CIRCUIT COMPARISON

ChryslerScanner

Original schematic -> current circuit sets

Original: Daniel Laszlo, revision 2.4.0-1, 2026-01-05. Current: Rev C, 24 pages / 329 circuit-probe endpoints.

16 Battery, VBB and VPP monitoring dividers

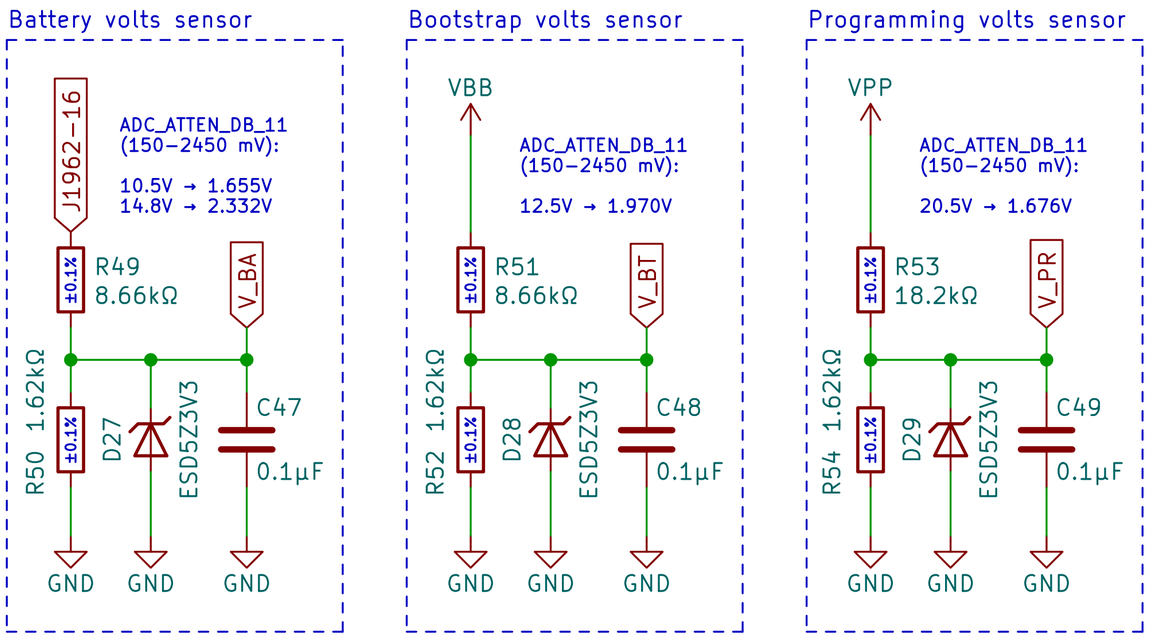
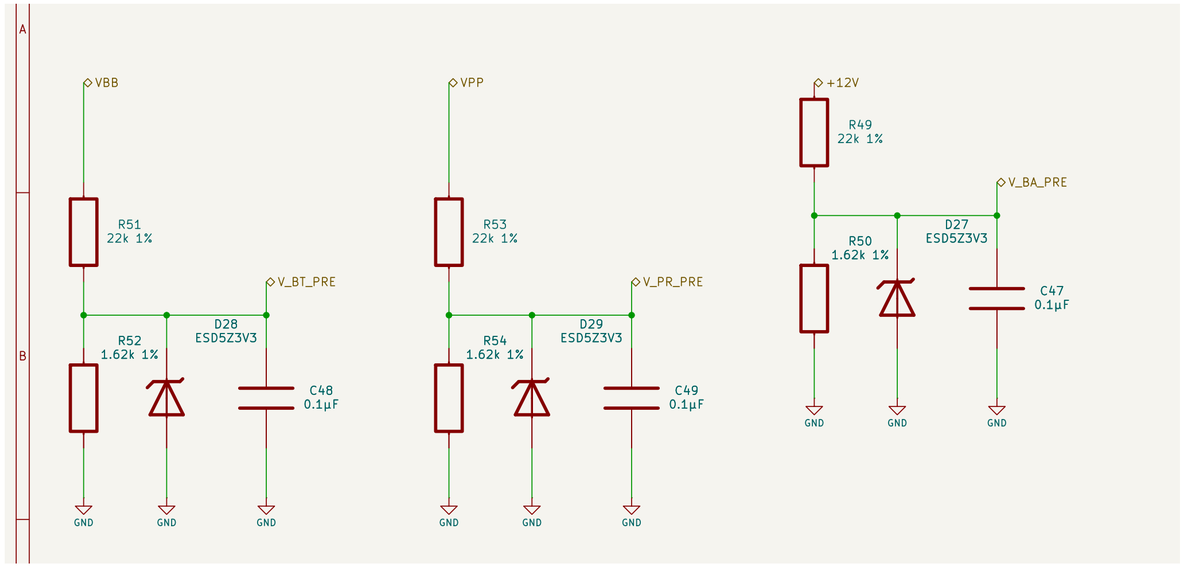
- R49/R51/R53 are now 22k 1%; R50/R52/R54 are 1.62k 1%. R49 input moves to protected +12V.
- The divider outputs are now V_BA_PRE, V_BT_PRE and V_PR_PRE. U21 isolation on the safety page creates the final ADC nets; calibration must reflect these intentional changes.

20 SCI pin 6: VBB / VPP programming switches

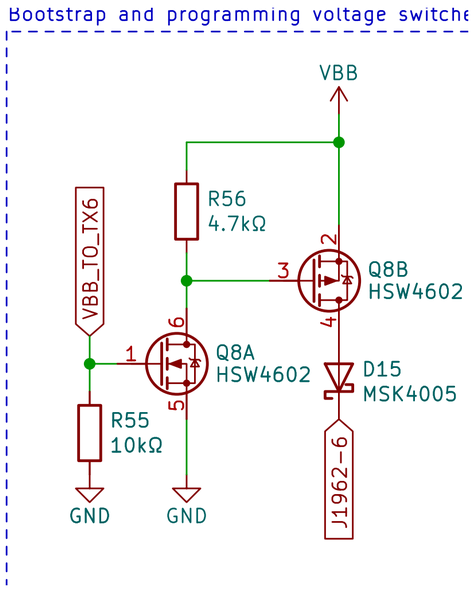
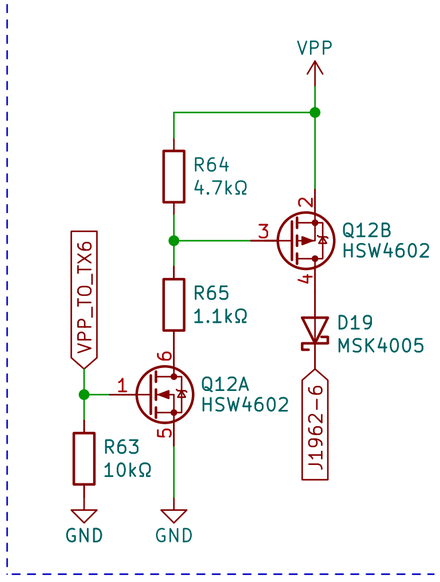
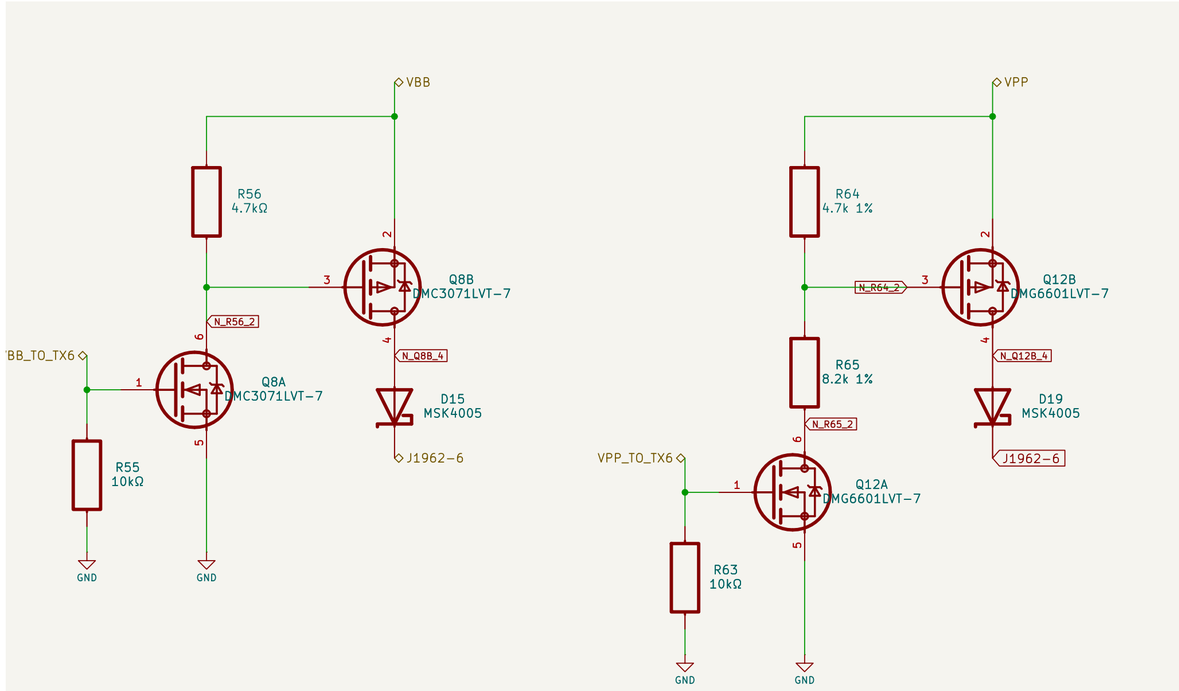
- The two rail-switching branches are paired by vehicle pin on a dedicated page.
- Q8-Q11 and Q12-Q15 use revised FET families. The VPP gate-divider values are intentionally revised to 4.7k / 8.2k; compare current labels rather than assuming identical parts.

21 SCI pin 9: VBB / VPP programming switches

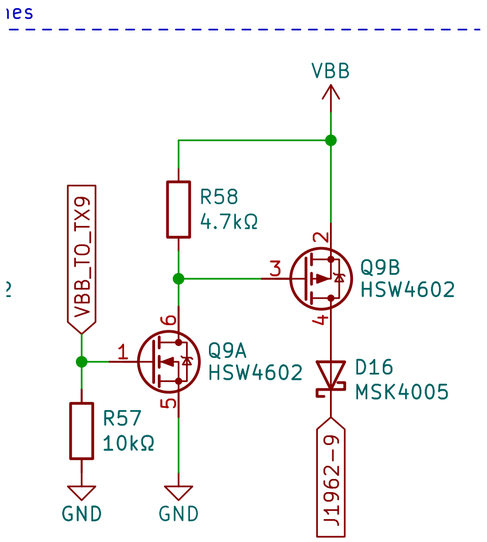
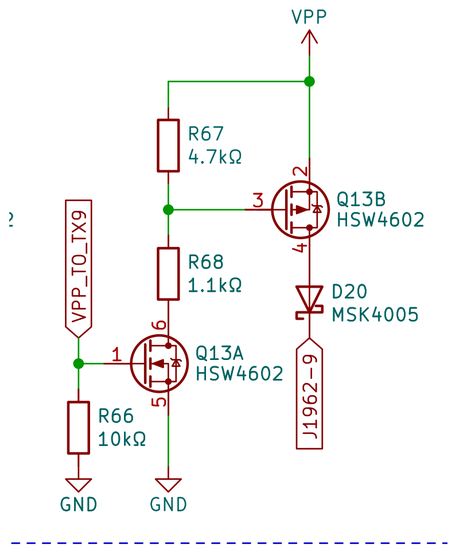
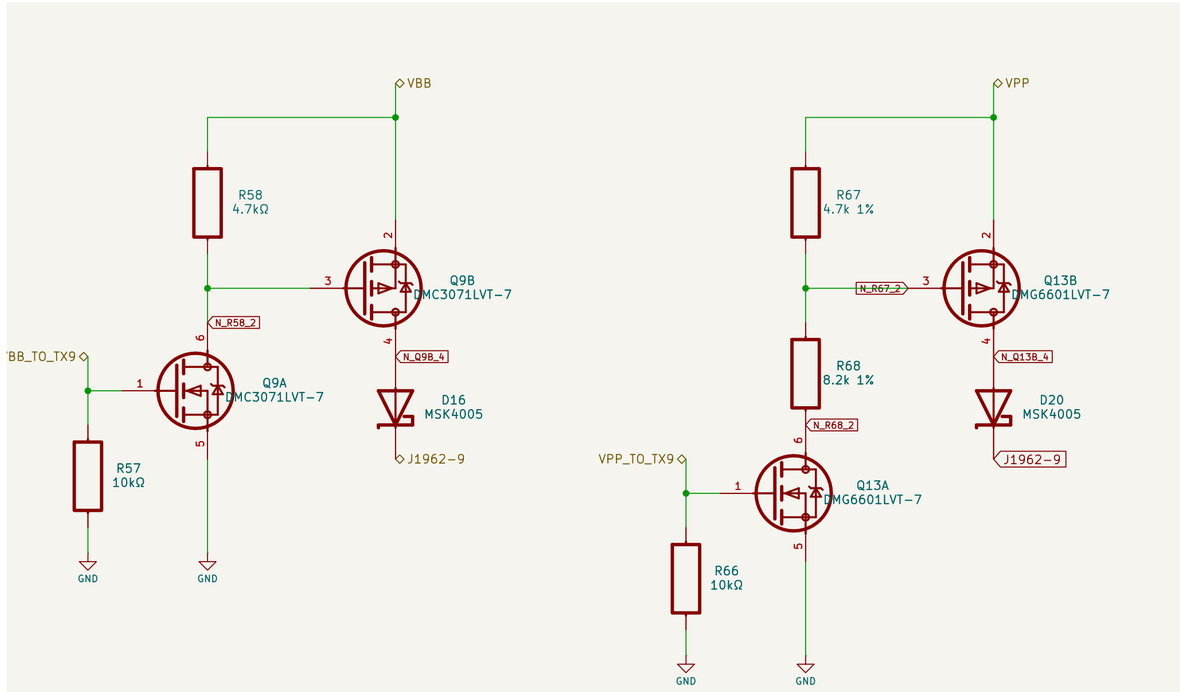
- The two rail-switching branches are paired by vehicle pin on a dedicated page.
- Q8-Q11 and Q12-Q15 use revised FET families. The VPP gate-divider values are intentionally revised to 4.7k / 8.2k; compare current labels rather than assuming identical parts.

22 SCI pin 12: VBB / VPP programming switches

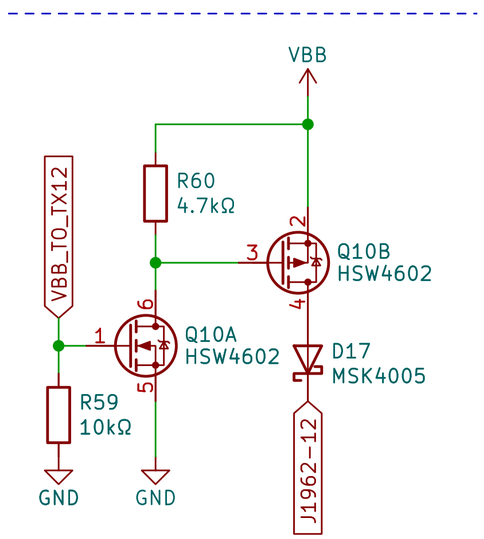
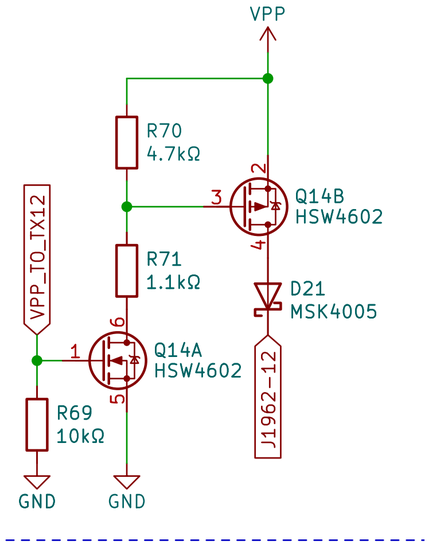
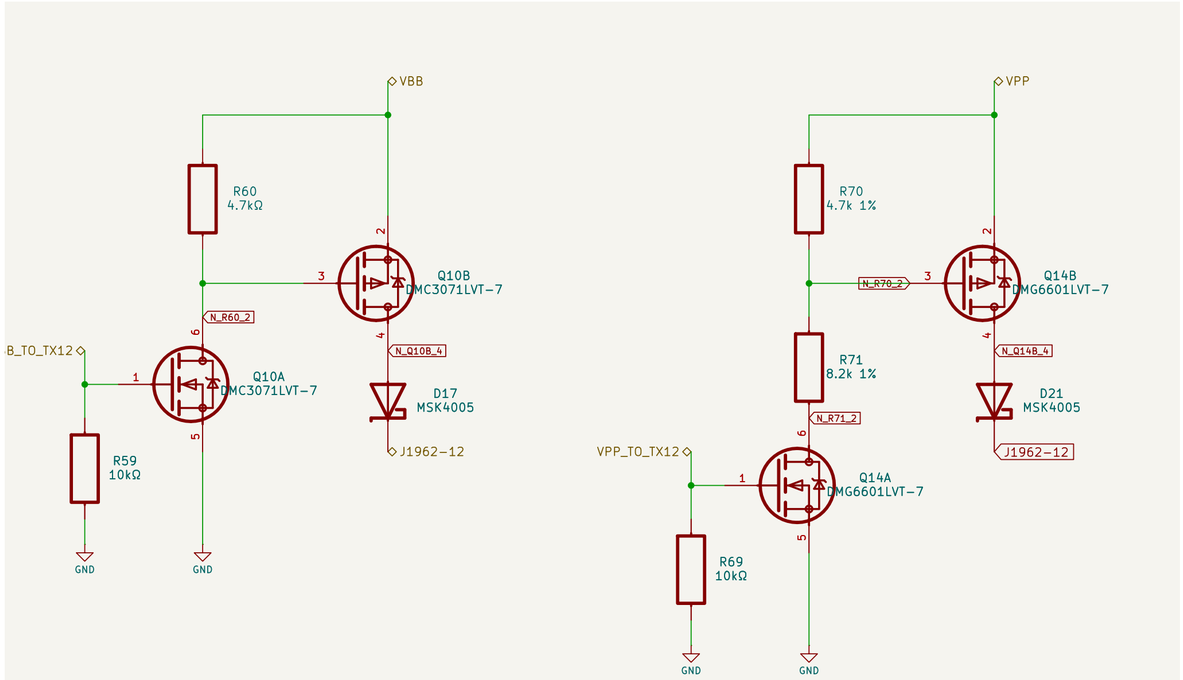
- The two rail-switching branches are paired by vehicle pin on a dedicated page.
- Q8-Q11 and Q12-Q15 use revised FET families. The VPP gate-divider values are intentionally revised to 4.7k / 8.2k; compare current labels rather than assuming identical parts.

23 SCI pin 14: VBB / VPP programming switches

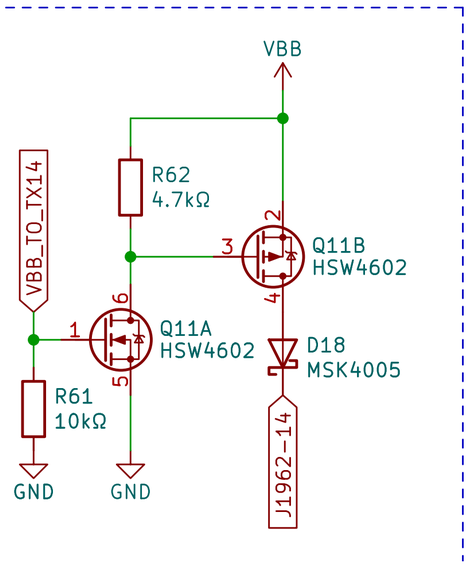
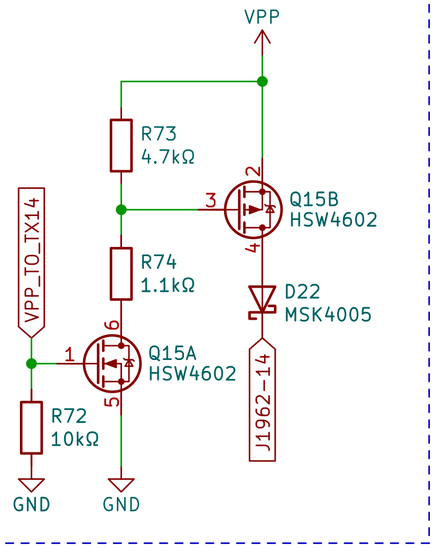
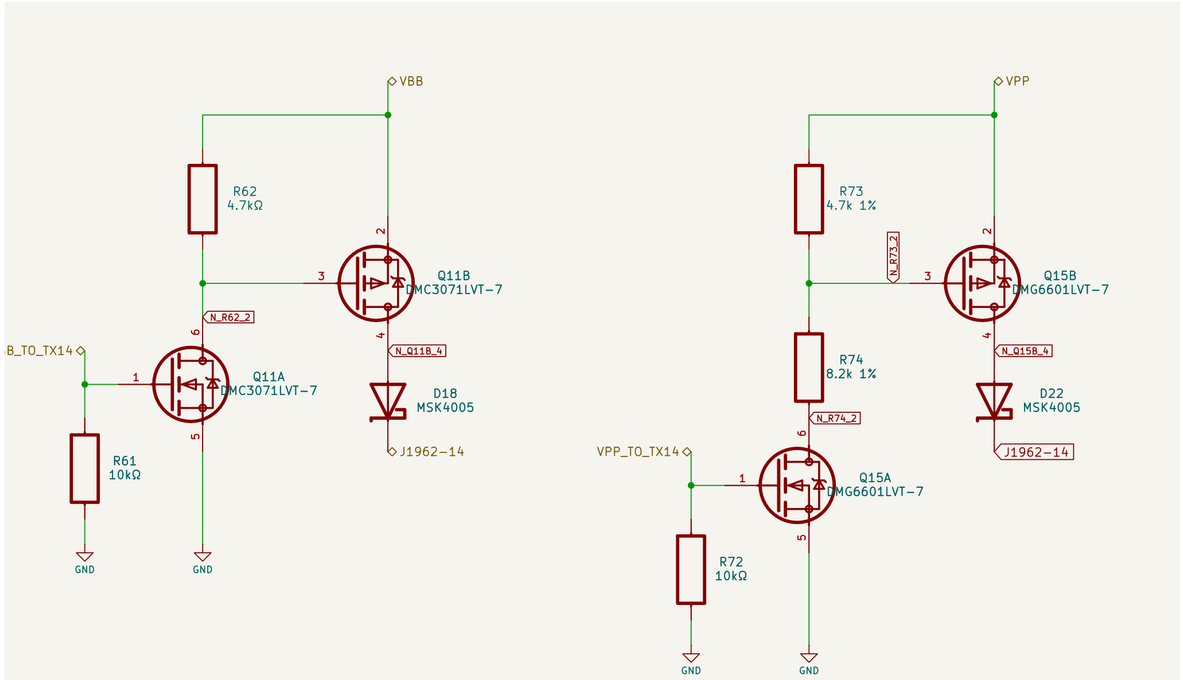
- The two rail-switching branches are paired by vehicle pin on a dedicated page.
- Q8-Q11 and Q12-Q15 use revised FET families. The VPP gate-divider values are intentionally revised to 4.7k / 8.2k; compare current labels rather than assuming identical parts.

24 I2C expander and internal connector

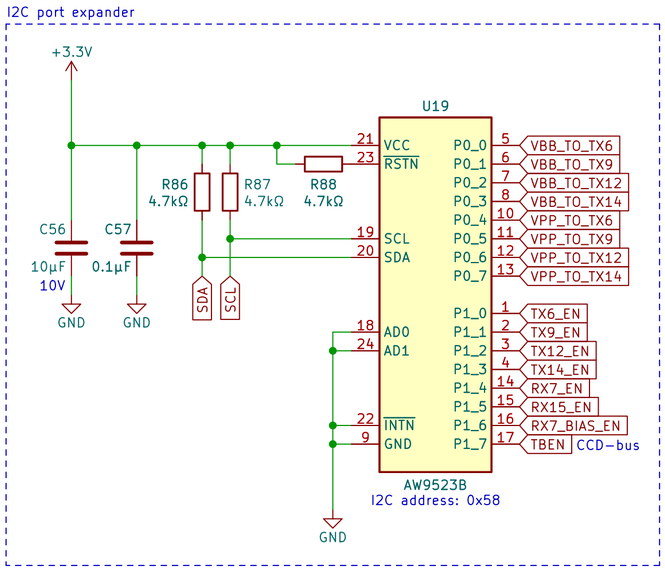
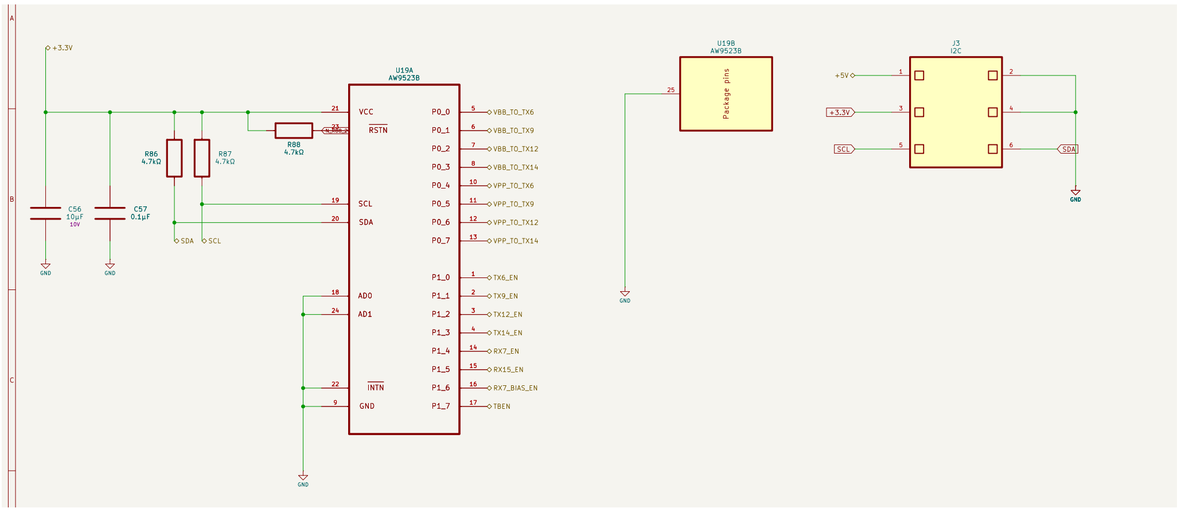
- U19 AW9523B, its 16 output functions, grounded address straps, I2C pull-ups and J3 are retained.
- The reset/permit net N_R88_2 is now driven by the new supervised hardware permit. The original independent reset pull-up is not sufficient by itself to describe the new safety behavior.

25 Status LED drivers

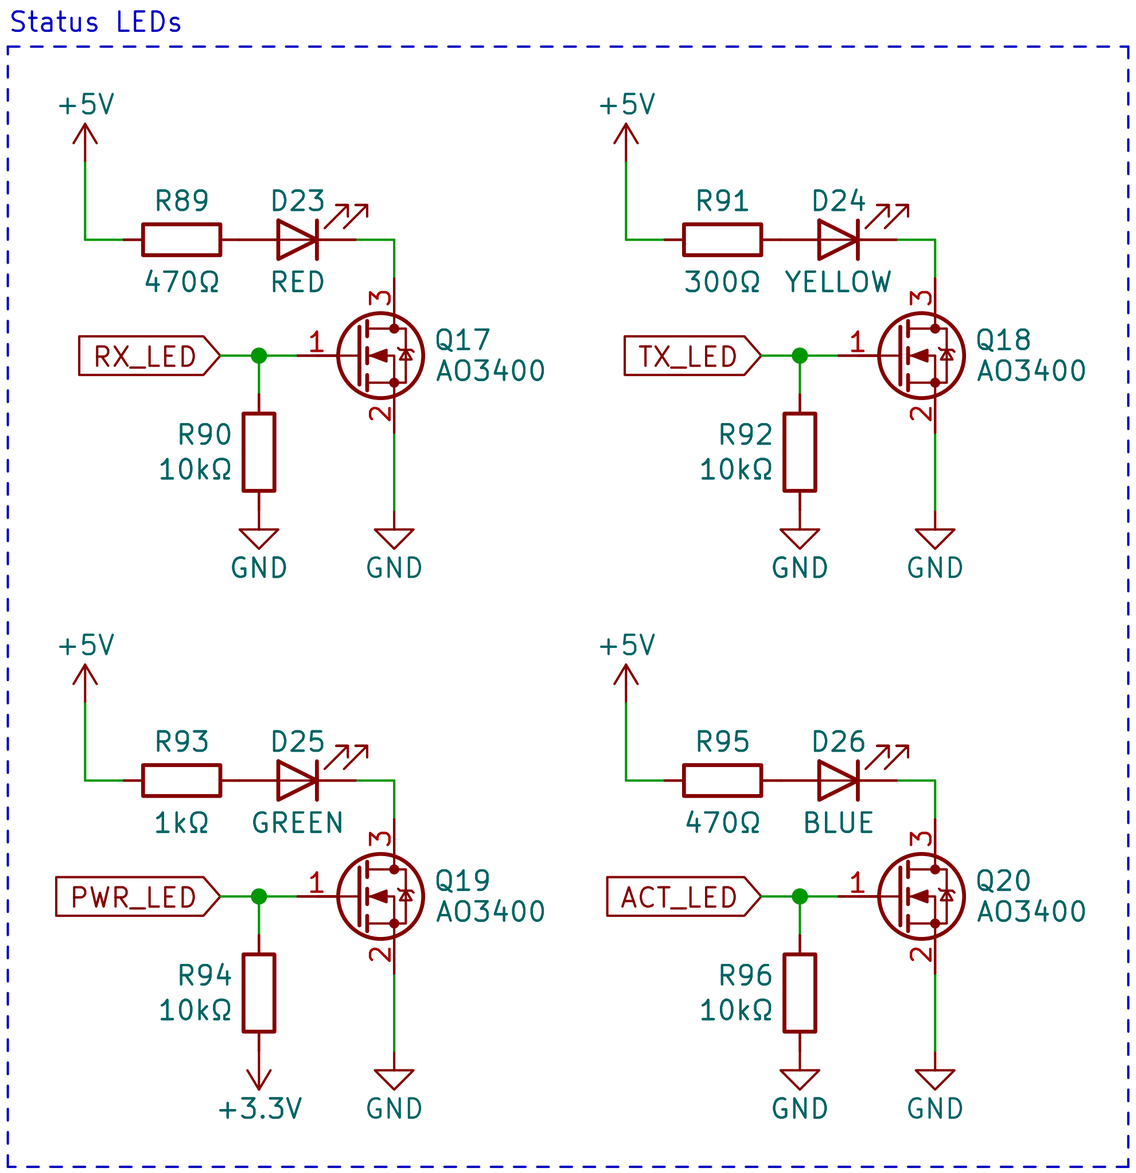
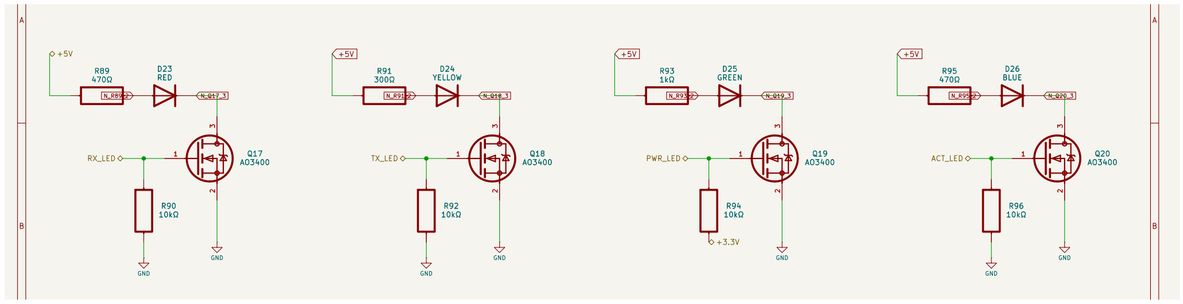
- D23-D26 and Q17-Q20 retain the four LED driver channels.
- The ACT_LED channel is now a dedicated health/permit indication. It must not be driven by the old general-purpose activity-blink code.
